# Broadmeadow East Mine Environmental Authority Amendment Application – Supporting Document

## Bowen Coking Coal Limited

Reference: P525016

1 March 2024

Figure 4-4 Updated Groundwater Monitoring Network

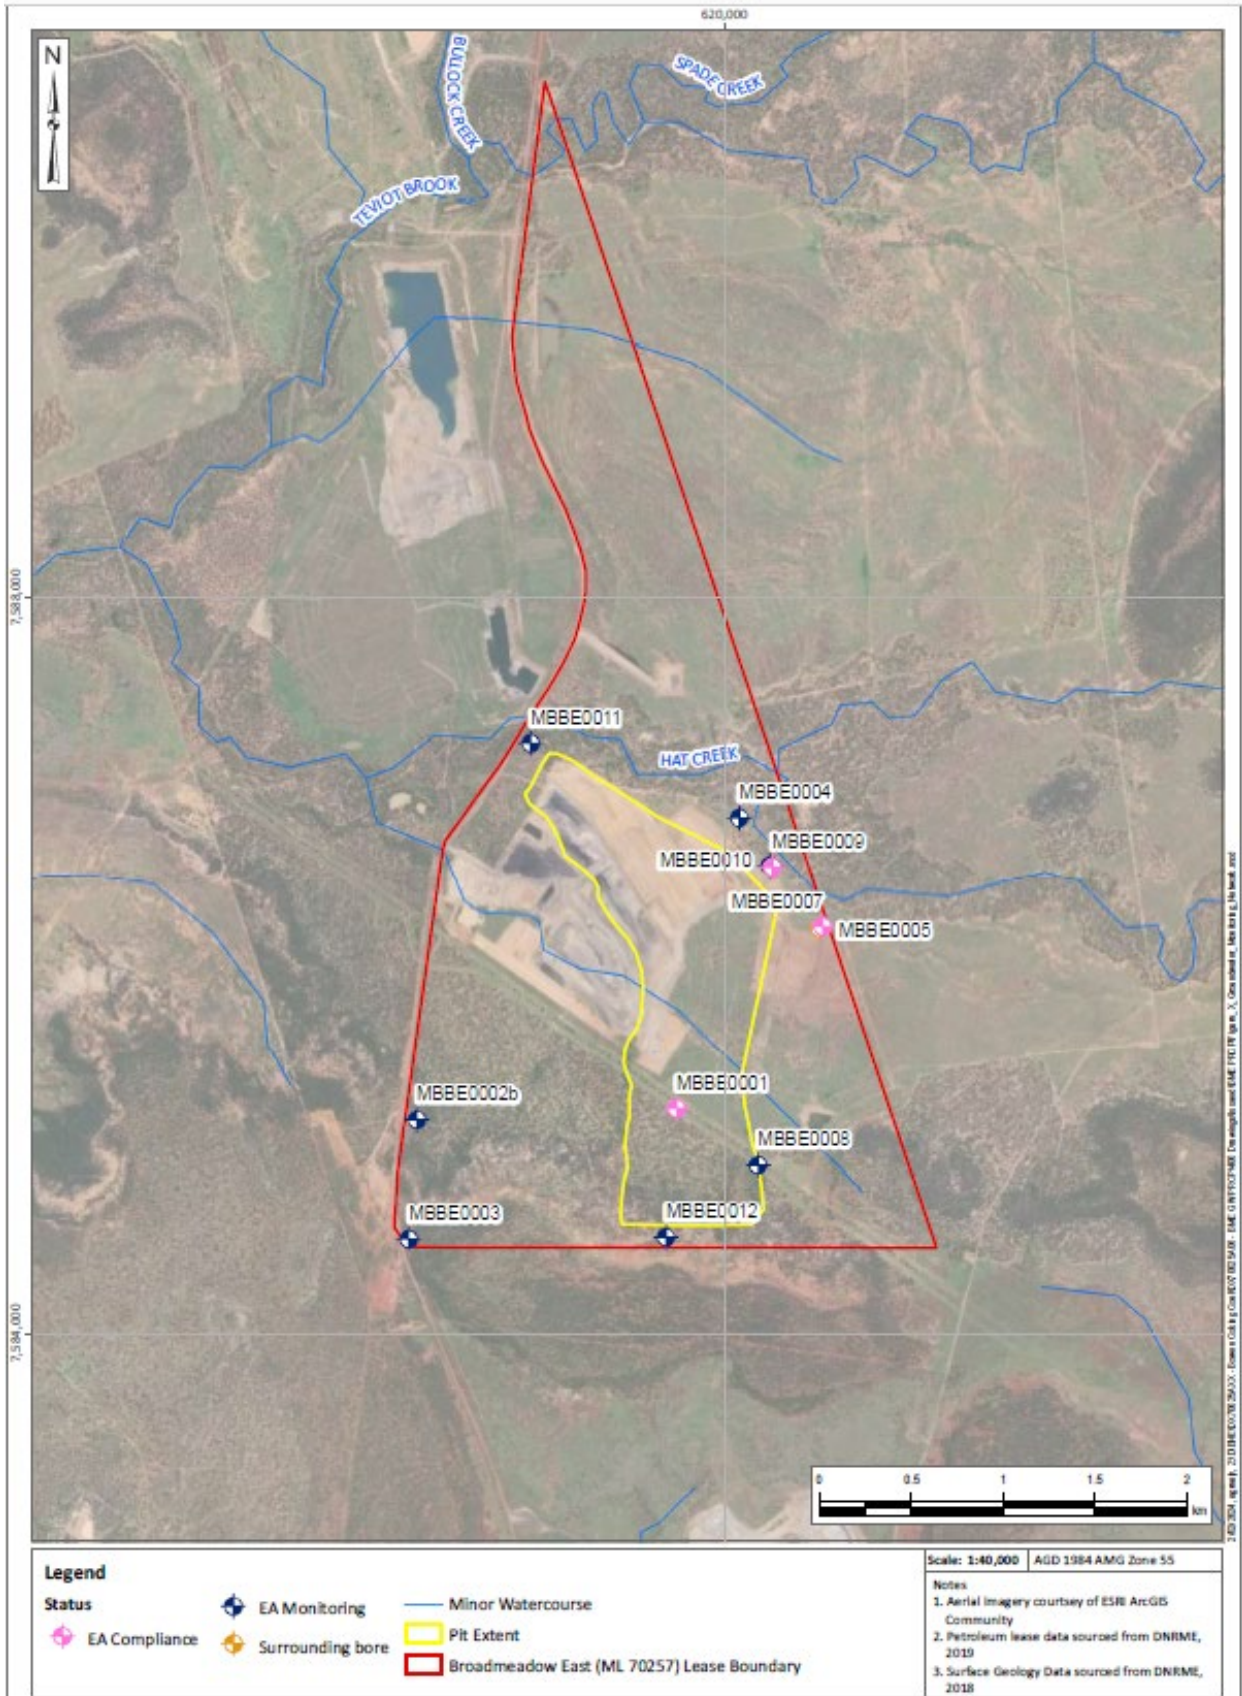
The updated location of groundwater bores is shown in Figure 4-4.

**Figure 5-8 Final landform design**

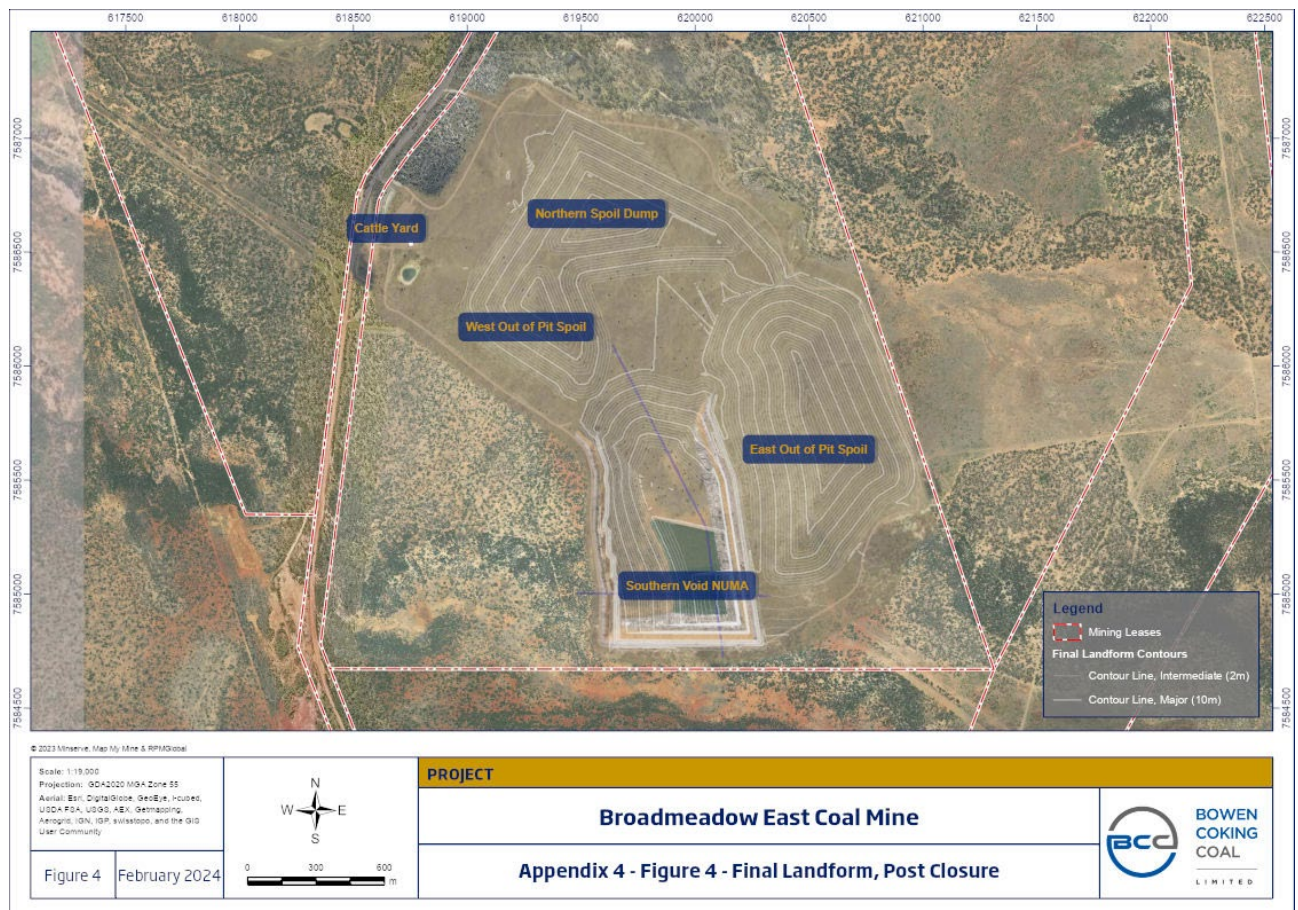
The final landform design for the Project is shown in Figure 5-8. It is proposed that this figure replace *Appendix 4 Figure 4 - Final Landform* in the EA (refer Section 8.1.4). As described throughout the PRCP (RPM Global, 2023a), the final landform consists of two out of pit dumps that closely border a predominantly backfilled pit to pre-mining topography with a Southern void remaining in the location that mining ceases.

## 8.1.4 Appendix 4 Figure 4 – Final landform, post closure

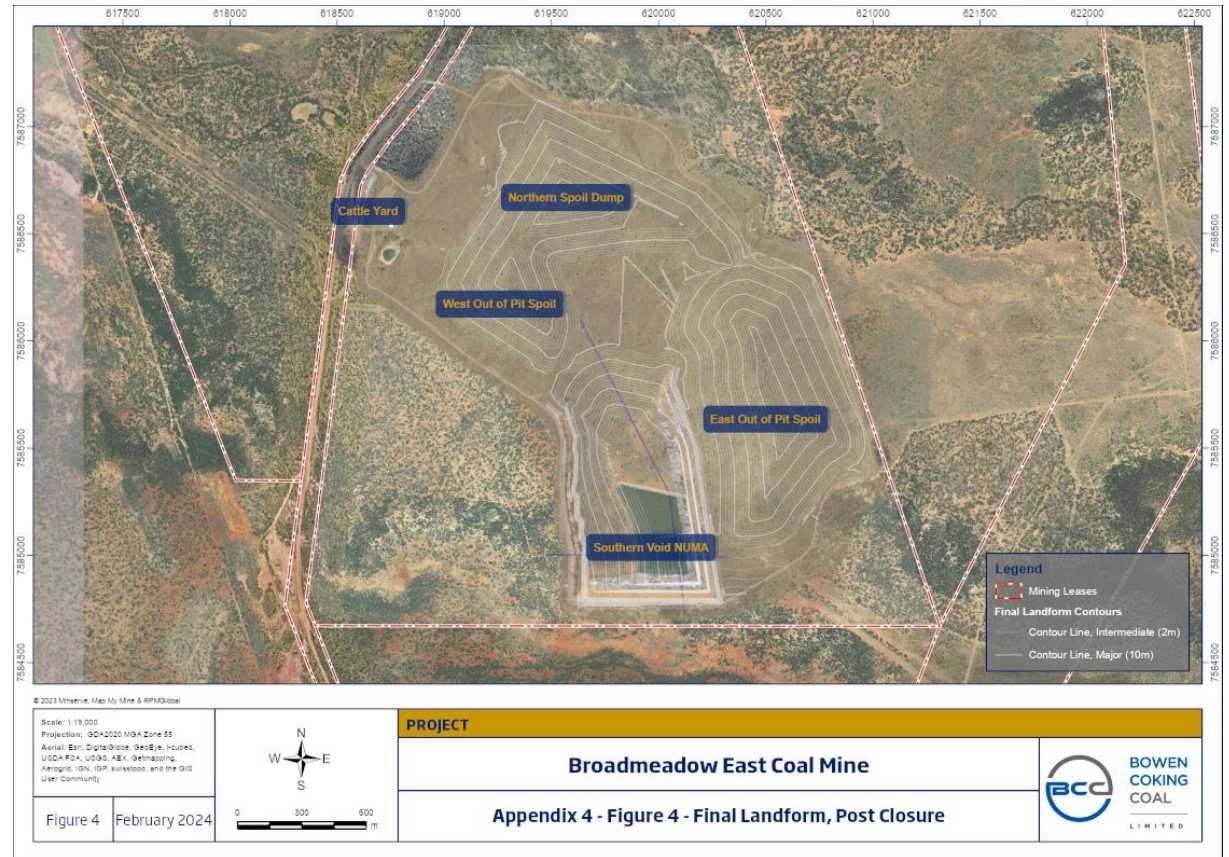
Existing Figure in EA

Proposed New Figure in EA
